Contact: Stuart Little
Telephone: 0436 948 347
Our ref: D2024/58608

**Planning Proposal to Rezone and Amend Minimum Lots Sizes on Lots at 274 Mountain Ash Road
Goulburn (REZ_0004_212; PP-2022-7072)**

ATTACHMENT 1 - DETAIL

Map 1. Strategic Land and Water Capability Assessment for 274 Mountain Ash Road

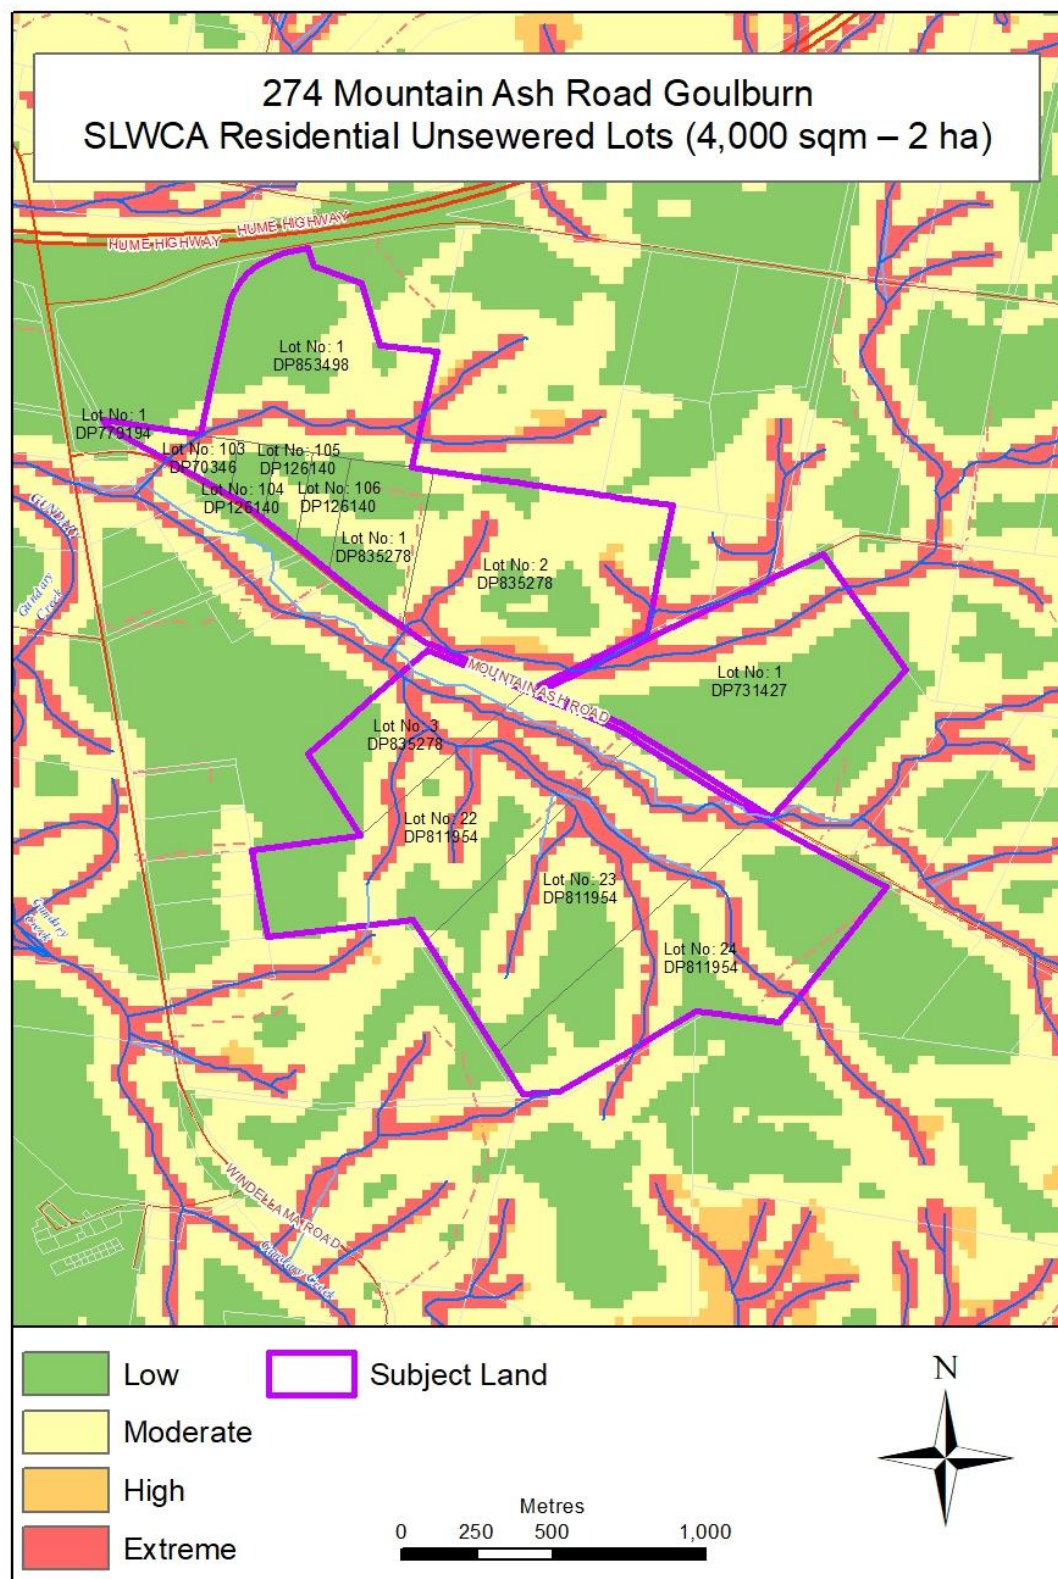
We have prepared a SLWCA for the site based on residential unsewered lots (4000 m² – 2 ha; Attachment 2). The SLWCA shows that the water quality risks for the site varies from LOW to EXTREME. The areas of EXTREME risk are associated with the drainage features and water courses. Areas of EXTREME risk have a VERY LOW capability while areas of HIGH risk have a LOW capability for the intended use. Areas of MODERATE risk have a MODERATE capability for the intended use while areas of LOW risk have a HIGH capability. Areas of HIGH and EXTREME risk should be avoided. These areas are largely encompassed by the proposed C2 zoning which will operate to protect water quality.

There appears to be sufficient areas of LOW and MODERATE risk to accommodate the proposed rural residential use of the land at the 2 ha MLS envisaged.

Please note that the SLWCA analysis does not take into account the flooding risk from riverine flooding or overland flows.
